ILLINOIS POWER COMPANY

CLINTON POWER STATION, P.O. BOX 678, CLINTON, ILLINOIS 61727

March 7, 1986

Subject: Clinton Power Station
Resolution of the Fire Protection Site Audit Concerns

DETAIL A21-1070-18
A29-1551-1 & A29-1551-2

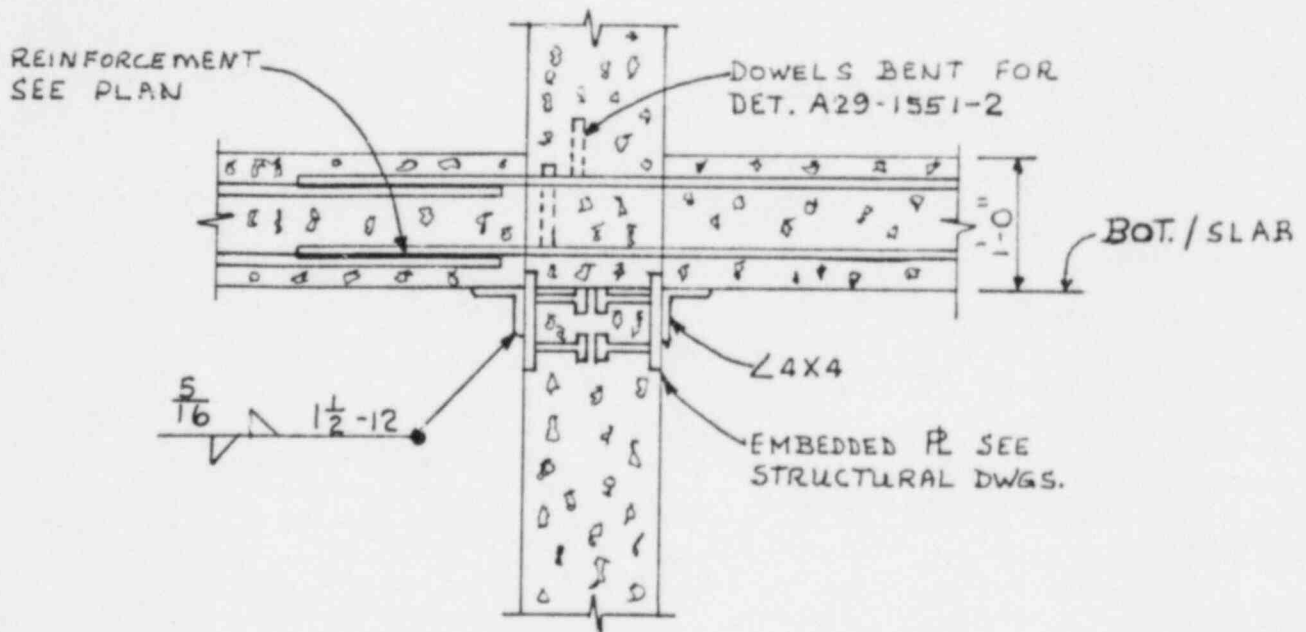
4. Unprotected Structural Steel in the Diesel Generator RoomsConcern

Structural steel forming a part of the fire barrier in the diesel generator day tank room is not protected. (Section D.1.(j) of Appendix A to BTP APCSB 9.5-1)

A design clarification is provided as Attachment (2) for the unprotected steel in this area. The steel involved is not structural steel.

The L4x4 member in the Diesel Generator Day Tank Room, as shown on the following Detail A21-1070-18, provided temporary support for the wet concrete of the roof slab and adds shear resistance to the joint detail. The angle is welded to an embedment plate similar to other attachments to concrete firewalls. This angle is not required to maintain the integrity of the roof slab.

Additionally, the concrete wall which has the embedment plate for the angle is continuous and has no gaps and therefore provides a continuous fire barrier.
